UNITED STATES PATENT AND TRADEMARK OFFICE

APPLICATION NO.	FILING DATE	FIRST NAMED INVENTOR	ATTORNEY DOCKET NO.	CONFIRMATION NO.
10/550,271	09/23/2005	Hiroyasu Yumura	017700-0177	1269
22428 7590 02/05/2007 FOLEY AND LARDNER LLP SUITE 500 3000 K STREET NW WASHINGTON, DC 20007			EXAMINER SOON, SHELDON STEWART	
			ART UNIT	PAPER NUMBER
			2809	
SHORTENED STATUTORY PERIOD OF RESPONSE		MAIL DATE	DELIVERY MODE	
3 MONTHS		02/05/2007	PAPER

DETAILED ACTION

Figures 3 and 4 taken from Snowden

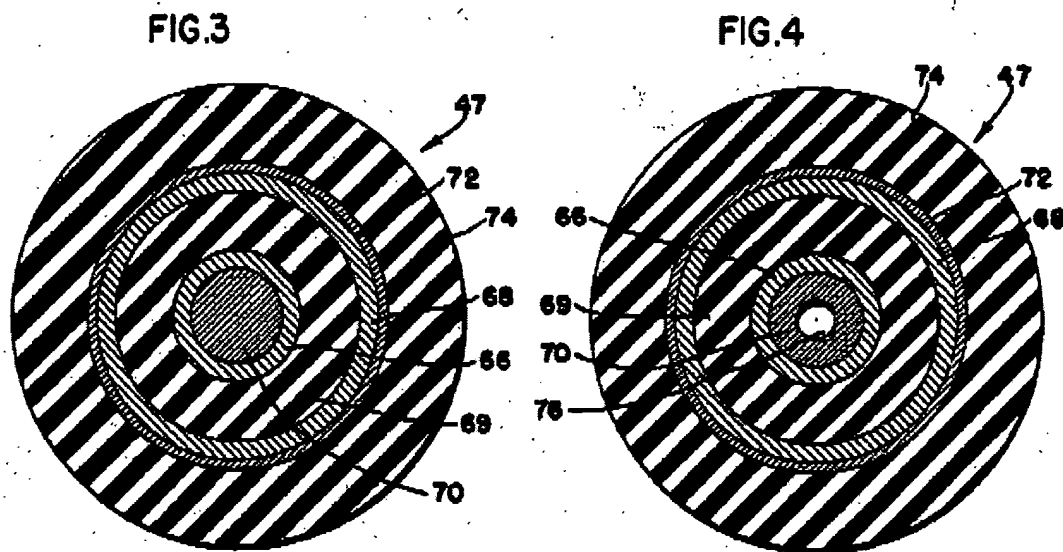
11. Claim 1 – Snowden discloses all the elements of the instant invention including, a superconducting cable (column 2 line 22), a former made of a normal-conducting metal (column 4 lines 18-22, item 70 above), a first superconducting layer (column 3 lines 71-73, item 66 above), an electrical insulation layer (column 4 line 1, item 69 above), and a second superconducting layer (column 3 lines 71-73, item 68 above). Snowden fails to show a normal conducting metal layer formed between the insulating layer and the second superconducting layer. Snowden does however show a normal conducting metal layer outside the second superconducting layer (column 4 lines 18-22, item 72 above). It would have been obvious to one having ordinary skill in the art at the time of the invention to exchange the position of the second superconducting layer with the normal conducting layer, since it has been held that a mere reversal of the essential working parts of a device involves only routine skill in the art. In re Einstein, 8 USPQ

167. Furthermore, this would reduce the electromagnetic interference between the superconducting layers.
